REVISED RESPONSE TO REQUEST FOR ADDITIONAL INFORMATION

APR1400 Design Certification

Docket No. 52-046

RAI No.: 13-7856
SRP Section: 12.02 – Radiation Sources
Application Section: 12.2
Date of RAI Issued: 05/22/2015

Figure 1. Shielding and Layout of Holdup Tank

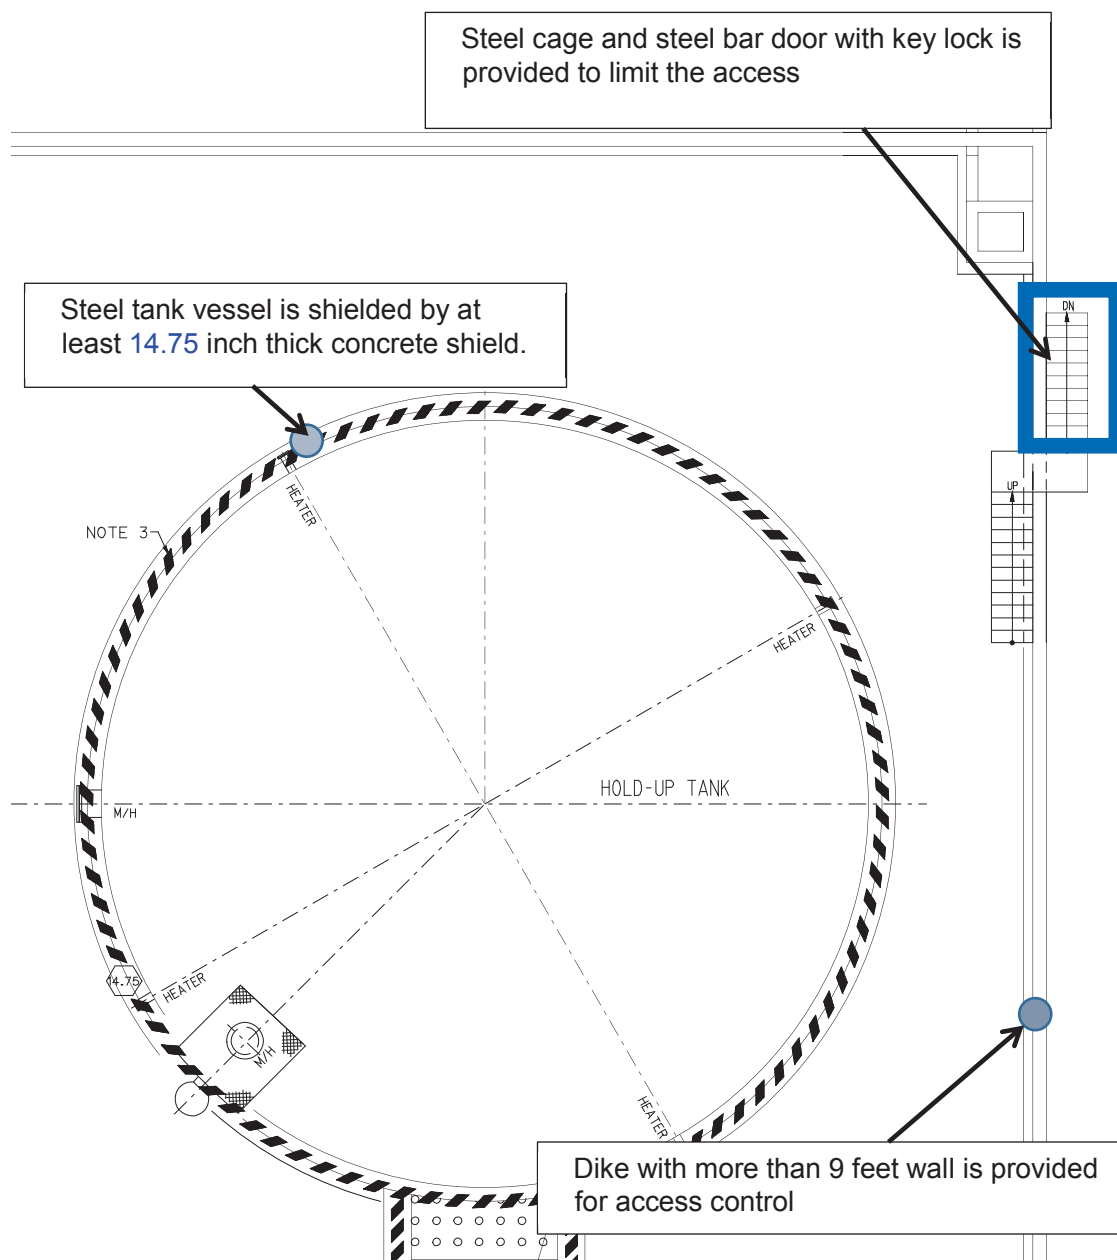
- a. Please describe these administrative controls or provide a COL item requesting that the COL applicant provide controls to provide the administrative controls ensuring that exposure to workers and members of the public from these tanks will be ALARA.

- b. As presented in Figure 1, the holdup tank itself is composed of a steel vessel with a minimum 14.75-inch thick concrete shield wall outside the vessel to ensure that the dose rate outside the tank is less than 2.5 $\mu\text{Sv/hr}$. This design feature is also applicable to the BAST. The RWMT is not shielded with concrete since the design basis dose rate outside the vessel is low enough to maintain the dose rate below 2.5 $\mu\text{Sv/hr}$ without the concrete shield wall.
